Contract #: 04-0120F4Cty: SF/ALA Rte: 80 PM: 13.2/13.9File #: 69.25B**QUALITY ASSURANCE -- NON-CONFORMANCE REPORT****Location:** Changxing Island, Shanghai, PRC**Report No:** NCR-000267**Prime Contractor:** American Bridge/Fluor Enterprises, a JV**Date:** 24-Apr-2009**Submitting Contractor:** Zhenhua Port Machinery Company, Ltd (ZPMC), Changxing Island**NCR #:** ZPMC-0241**Type of problem:**

Reference Description: Continuity Plate Retrofit, Doubler Plates**Description of Non-Conformance:**

Job Name: SAS Superstructure

Subject: NCR No. ZPMC-0241

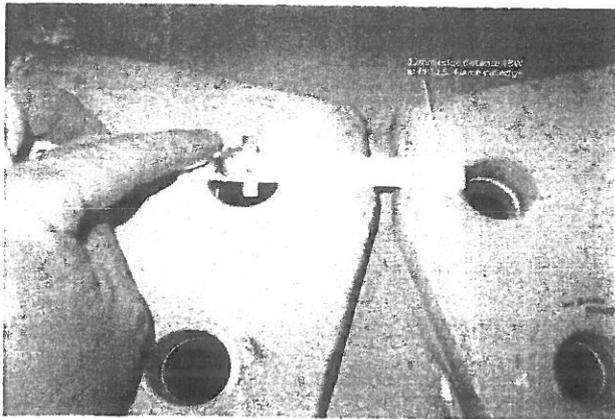
At locations where there are consecutive doubler plates between the closed ribs, trimming the corners of the doublers is necessary for proper fit-up. On Segment 1BW, Panel points PP11.5 and PP12.5, the bolt hole edge distance to the trimmed (flame cut) edge of the doubler plates was observed to be 22mm (edge of hole to edge of plate). This does not meet the minimum edge distance requirement of 1.75D, which in this case is 28.5mm from the edge of the 27mm hole to the edge of plate.
